<i>Title:</i>	SMALL-SCALE EXPERIMENTS: EFFECTS OF CHEMICAL REACTIONS ON DEBRIS-BED HEAD LOSS
<i>Author(s):</i>	R. C. Johns and B. C. Letellier Los Alamos National Laboratory K. J. Howe and A. K. Ghosh University of New Mexico
<i>Submitted to:</i>	US Nuclear Regulatory Commission

**SMALL-SCALE EXPERIMENTS: EFFECTS OF CHEMICAL REACTIONS  
ON DEBRIS-BED HEAD LOSS**

**A Subtask of GSI-191**

**Prepared for  
Division of Engineering Technology  
Office of Nuclear Regulatory Research  
US Nuclear Regulatory Commission  
Washington, DC 20555-0001  
NRC Job Code Y6041**

Fig. 2-1. Illustration of a LLOCA event occurring in a PWR plant.

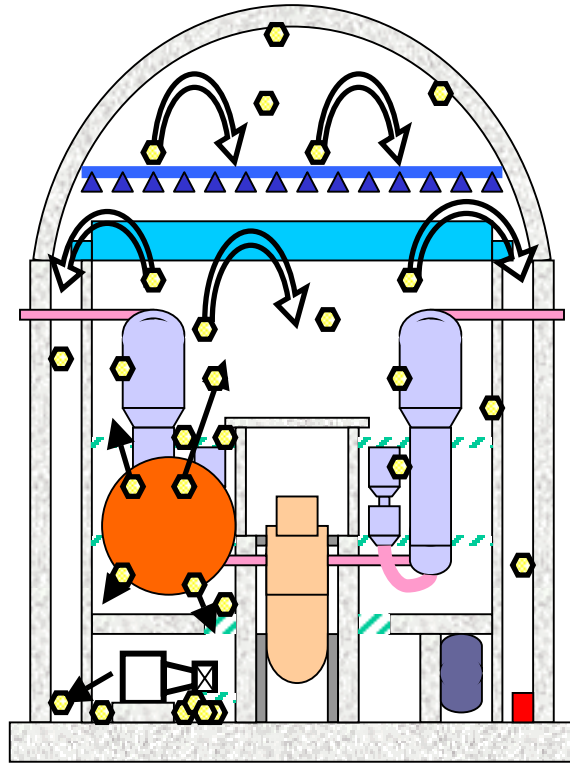
- 4) Improve or replace the time-line given on Figure 2-1. There is too much detail in the blowdown phase and not nearly enough in the later phases, where the processes important to screen blockage, take place. Perhaps the time-line format of Appendix C should be adopted. In any case, add more information. Put in the system temperature for each phase of the transient. Put in the water level and the pump and spray flow rates. A lot more detail in the period from 0.25 hours to 24 hours is needed.

Pg. 5, Figure 2-1. This figure is not adequately discussed. I would recommend that it be combined with Table 2-1 and Appendix C to provide a more comprehensive picture of the time/temperature/chemical environment that is the basis for your tests.

There is mention of “long-term headloss”. Need a brief discussion of what this means. It would be nice to tie the discussion into Figure 2-1, and put the time frame in the context of the LLOCA.

Again, Figure 2-1 needs to be expanded and integrated. It should be possible to integrate the information in the appendix either into the figure or into the discussion of the figure.

Fig. 4-2. Schematic of small-scale test loop.

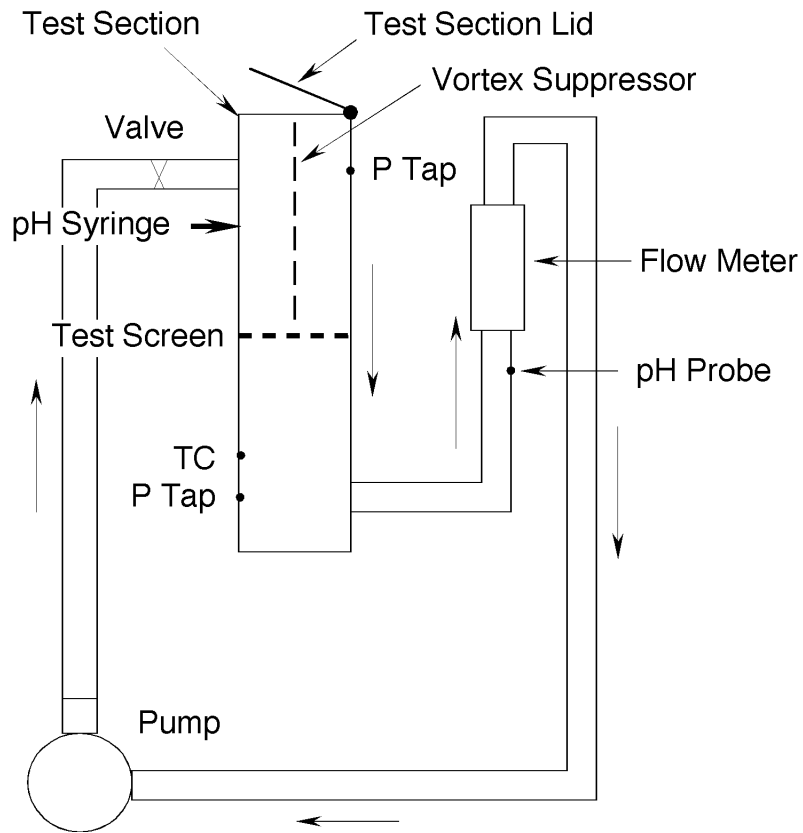
Section 4.3 – Include labeling of lid and vortex suppressor in Figure 4.2.

Fig. 4-9. Head loss vs material concentration.

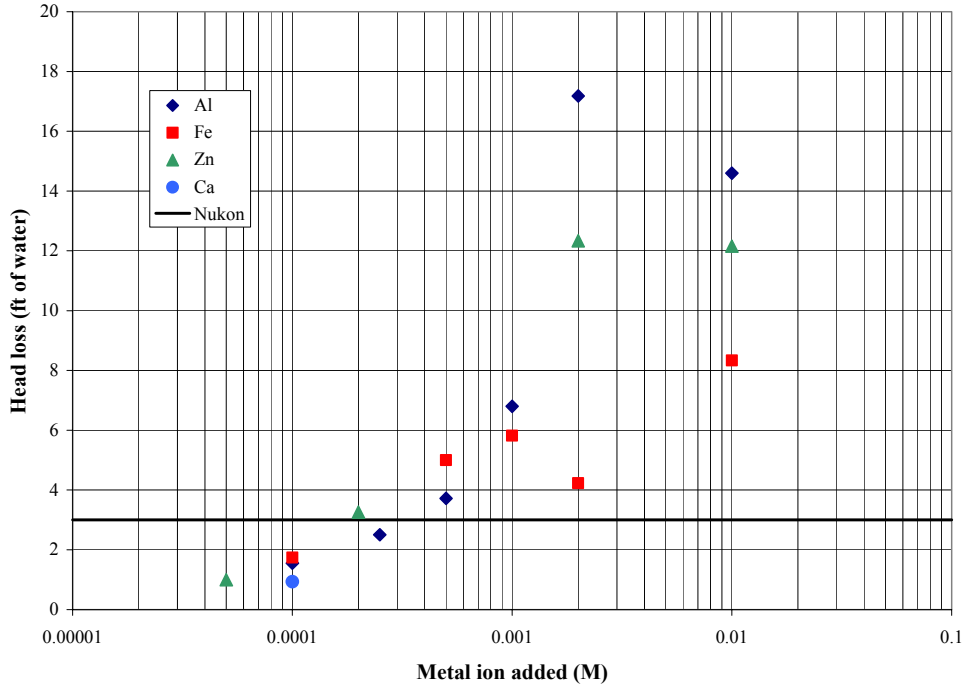
- a) Replace the variety of metals that are in the pool by an equivalent quantity of zinc. (I believe Figure 4-9 of the draft report can be used to justify what is selected.)

- 6) Reduce the head loss results of Figure 4-9 to a form of flow resistance which can easily be used by someone trying to evaluate the safety of a plant. As the results are presented now they are in a form peculiar to the apparatus used by you. I also suspect that most of your data is not in the range of pressure drops or mass velocities of interest to a user. I suspect that they are too high. Extrapolate right down to zero or a very low flow rate. Don't ask the user to extrapolate or reduce your data, do it for him.

Figures 4-9 and 4-10 – Include only the data from the experiments that met the test requirements of time and temperature. Provide a fitting curve for each type of data.

Fig. 5-19. Zinc granules after exposure (oven at 80° C for 3 days) under optical microscope (magnification 49).

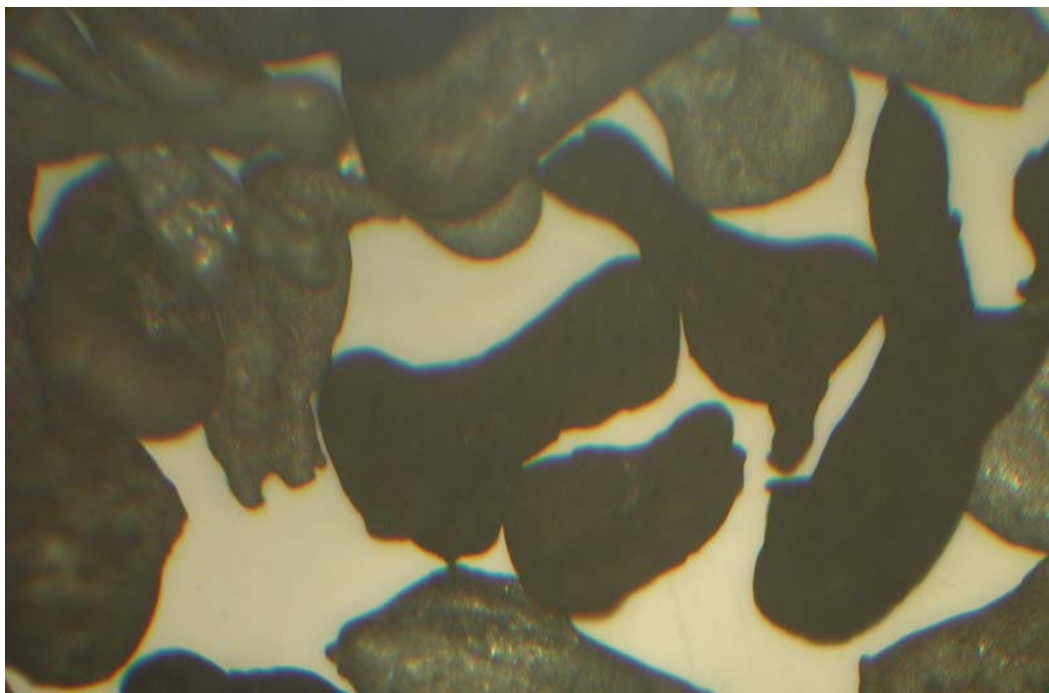
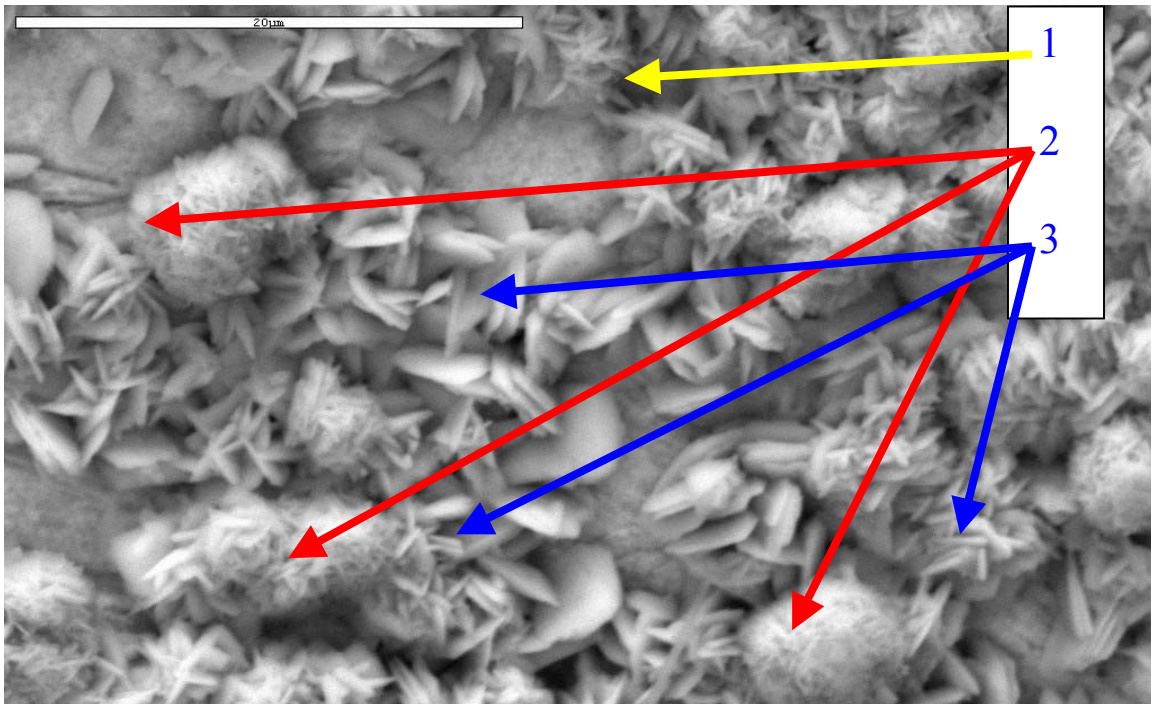
Figures 5-19 to 5-21 – What is your explanation of the differences in these figures?
